IV. Remarks

Appln. No. 10/004,758

Patent Application for BEARINGLESS PINION WITH CLEANING EDGES Inventor(s): Monroe et al. Application No.: 10/004,758; Attorney Docket No.: 10541-636 Annotated Replacement Sheet Mailed July 22, 2004

Replacement Sheet 1:

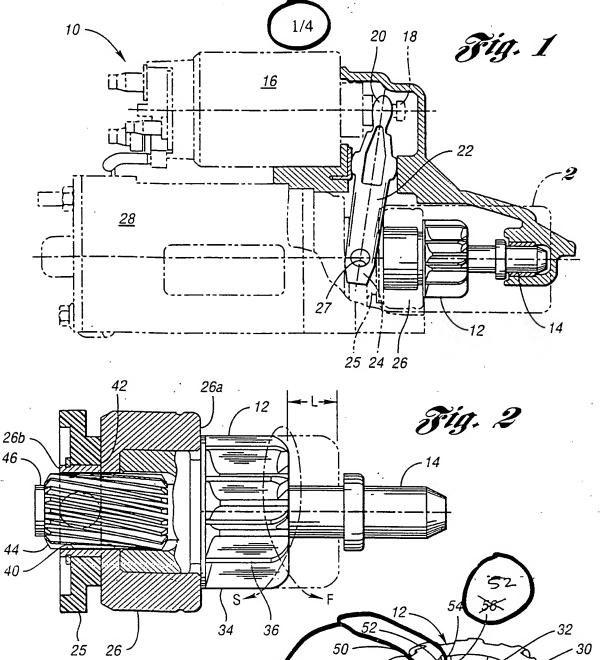
Figure 3 has been amended to replace one of the occurrences of reference numeral 56 to the reference numeral 52. Paragraph [0019] of the original Application as filed recites that the primary edge 52 is formed along the length of inner surface 32 and that the primary edge 52 forms a groove 54. Paragraph [0020] of the original Application as filed recites that the secondary edge 56 radially extends on the end face 50, and original Figure 3 in the Application as filed shows another occurrence of the reference numeral 56 properly pointing to the secondary edge 56 extending around the end face 50. Therefore, the amended reference numeral should be 52 rather than 56 and no new matter is added.

Furthermore, Figure 3 has been amended to extend the reference line of one of the occurrences of reference numeral 52 to the primary edge 52 formed along the length of inner surface 32. As discussed above, Paragraph [0019] discloses the primary edge 52 as being formed along the length of inner surface 32 and as forming a groove 54. Therefore, the amended reference line should extend to the primary edge 52 forming the groove 54 and no new matter is added.

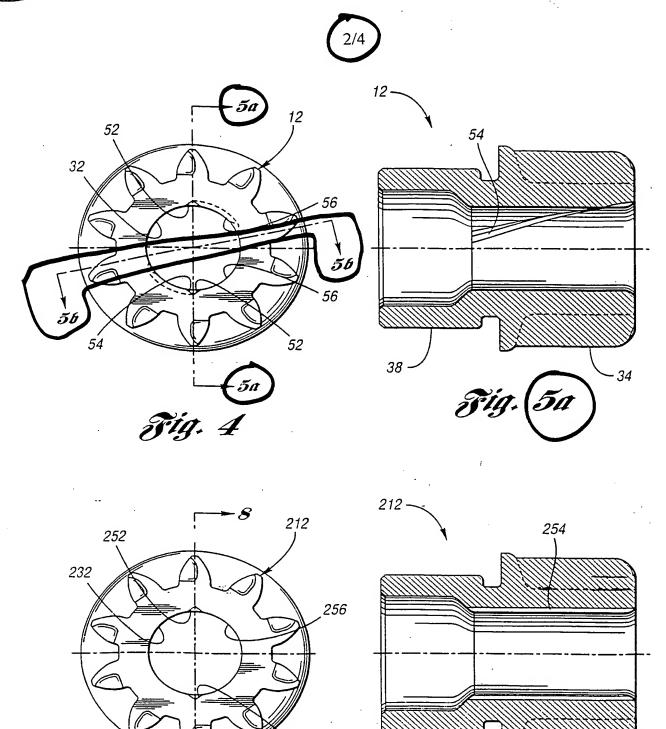
Figure 4 has been amended to renumber line 5-5 as line 5a-5a and to include an additional cross-sectional line labeled 5b-5b. As a result, Figure 5 has been renumbered as Figure 5a.

Furthermore, Figure 5b has been added as a cross-sectional view of Figure 4 taken along line 5b-5b in order to show the angle 51 of the secondary edge 56 that is defined by the inner surface 32 and the end face 50 of the pinion 12. Figures 3-5, 7, and 8 collectively show that the inner surface 32
